MEMORANDUM

To: Development Review Board
From: Ryan Morrison, Associate Planner
Date: March 17, 2020
RE: 20-0677CU; 52 Appletree Point Road

Request: The applicant seeks approval to rent out one apartment in the existing duplex as a one bedroom bed and breakfast short term rental.

TO: Development Review Board
FROM: Ryan Morrison
DATE: March 4, 2020
RE: 20-0674CU; 50 Lakeside Avenue

PARKING S2A

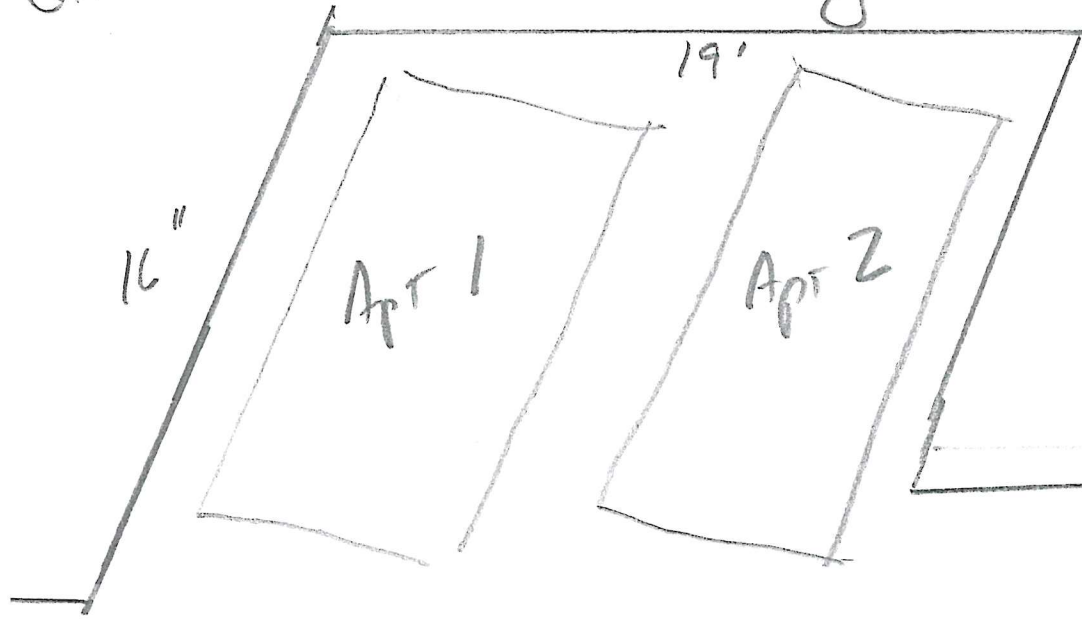
This parcel is located along Appletree Point Road, a residential street. The driveway and two-car garage combo provides adequate space to accommodate the three required parking spaces. There is a transit stop within walking distance at the intersection of Appletree Point Road and Staniford Farms Road (approximately 550 ft from the property). A sidewalk lines one side of Appletree Point Road, the same side as the subject property. **Affirmative finding.**

PHASE	
PHASE 5B	
BUILDING 50	
ENLARGED TENANT FLOOR PLAN

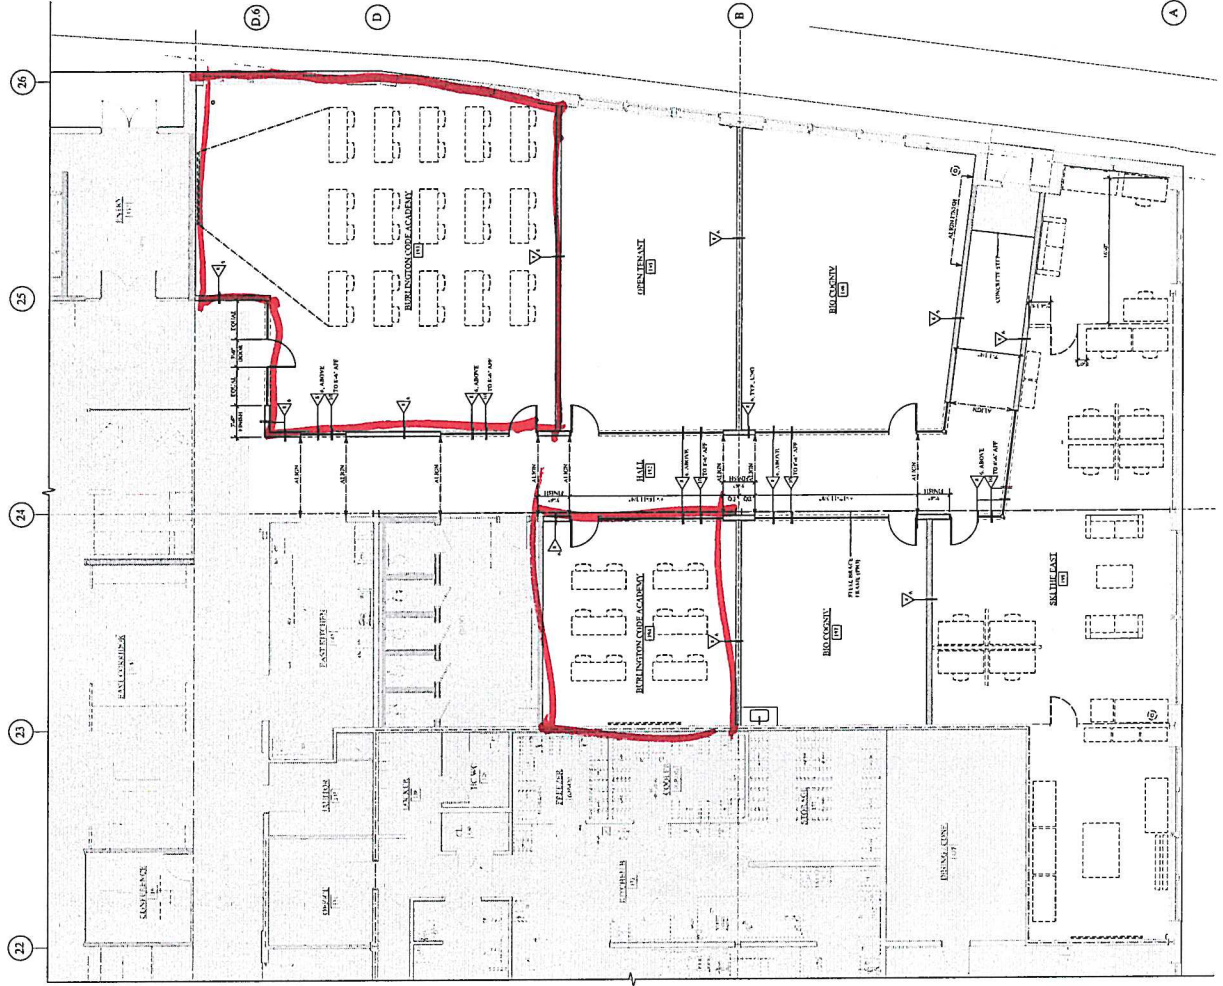
The applicant for the proposed trade school at 50 Lakeside Avenue is requesting to add 450 sf of additional classroom space to the originally proposed 1,370 sf space (see attached floor plan). With the increase of floor area (1,820 sf), the parking requirement for the use increases from 4 spaces to 5 spaces. As noted in the staff report for this project, the overall property development will have 381 parking spaces when only 286 spaces are required for all uses on site. The additional parking space requirement for this increase in floor area for the trade school will be met.

ELEVATION

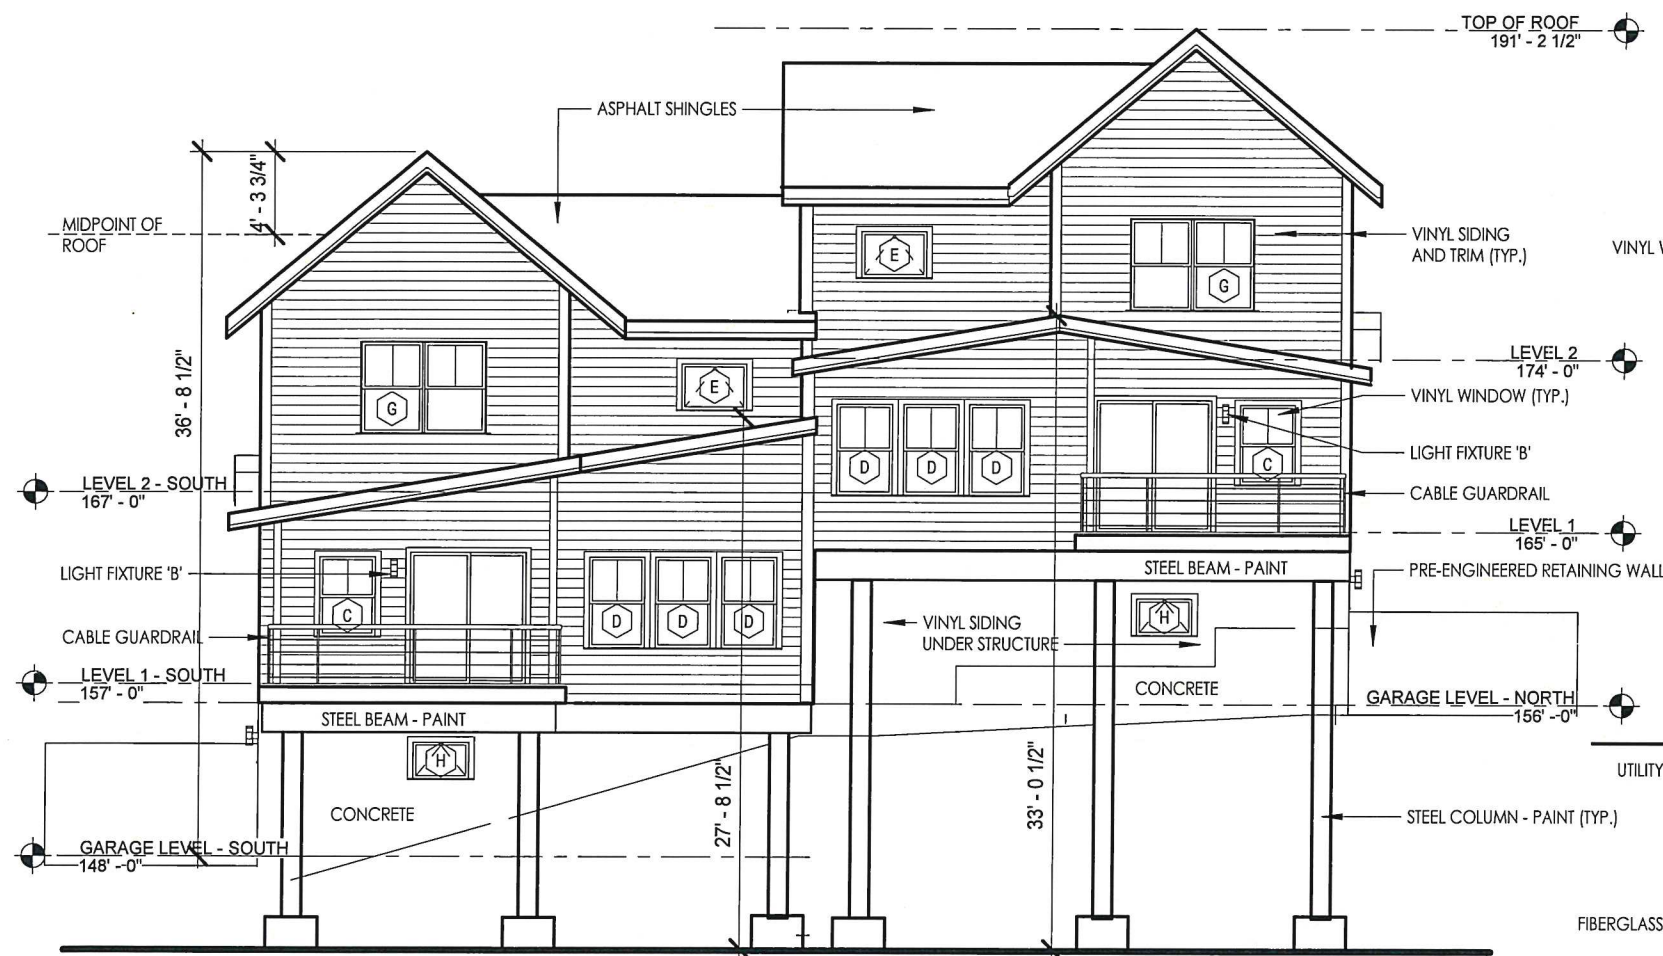
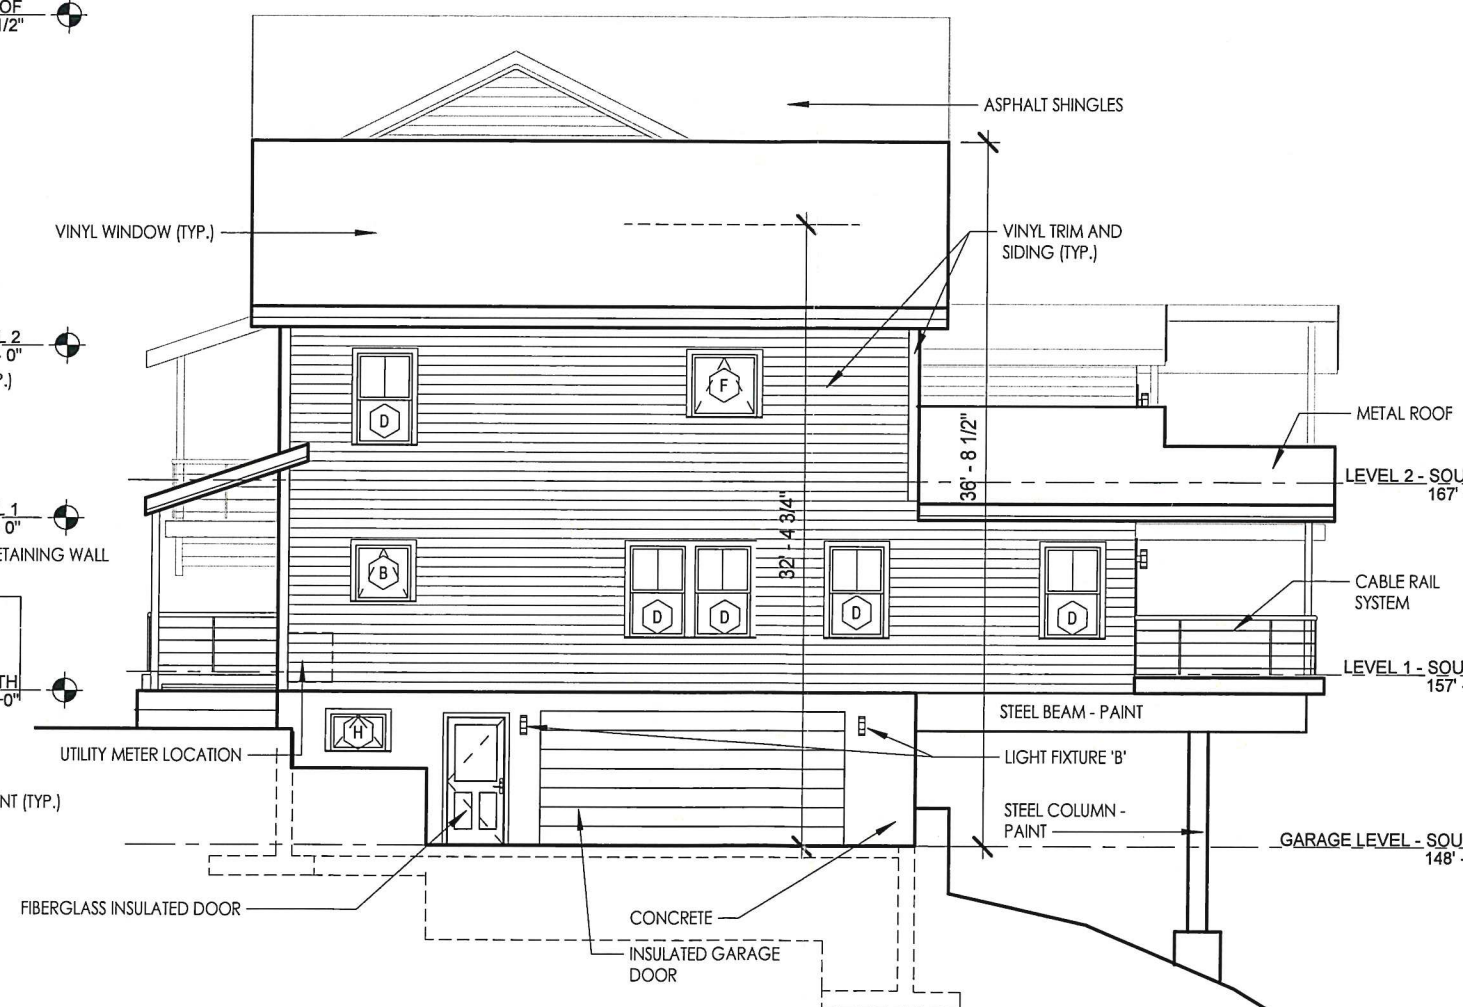
Lighting fixture spec sheets have been provided, and the elevation drawings show the location of the proposed fixtures. The fixtures comply with the lighting standards of this section. **Affirmative finding.**

The massing, height, and scale of the proposed duplex is consistent with that of existing homes within this neighborhood. The homes come in a variety of typically suburban forms and styles. Each unit will have covered front porch entries, which will provide for a clear distinction between the first and second floor. Building openings on the front façade will break up any possibility of a blank wall. As viewed from the street, the height will be consistent with the heights of other nearby homes. **Affirmative finding.**

The front doorways are clearly articulated. There are no large blank walls or expanses of roof. Fenestration and roof variations work successfully to provide an active and inviting street elevation. **Affirmative finding**
